September 8, 1992

We wanted to write and share some safety features that we have added to our batting ranges. Please read this material carefully.

Batter's Box Layout

figure 1.0

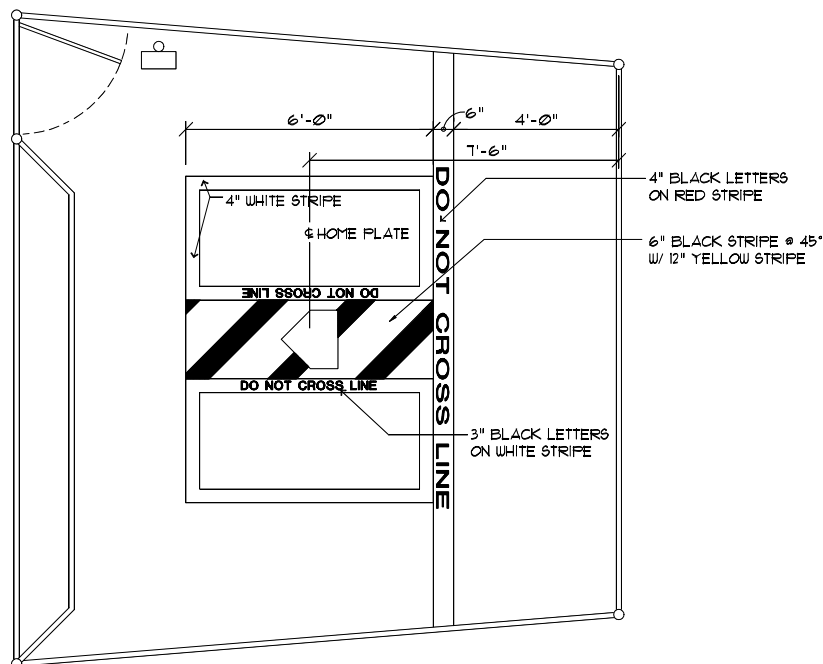
The illustration below (figure 1.0) is an overview of a typical batting stall and batters box. Please note the 7'-6" dimension from the opening of the stall to the center of Home plate. This dimension will ensure the "Batters Box" is adequately back far enough from the opening of the stall and reduce the risk of "fouled balls" striking another batter. If your Batters Box is not at least 7'-6" as shown, you will need to move your boxes back.

Also note that we suggest you paint a red "**DO NOT PASS RED LINE**" line as shown on this drawing. The purpose of this line is to keep customers from going forward of this line. We clearly do not want customers out in "open" area, in the "pit", or batting in an area which will cause the flight of the ball to enter another stall.

Please implement these changes or additions for the stalls immediately. If you have any questions please call ABC.
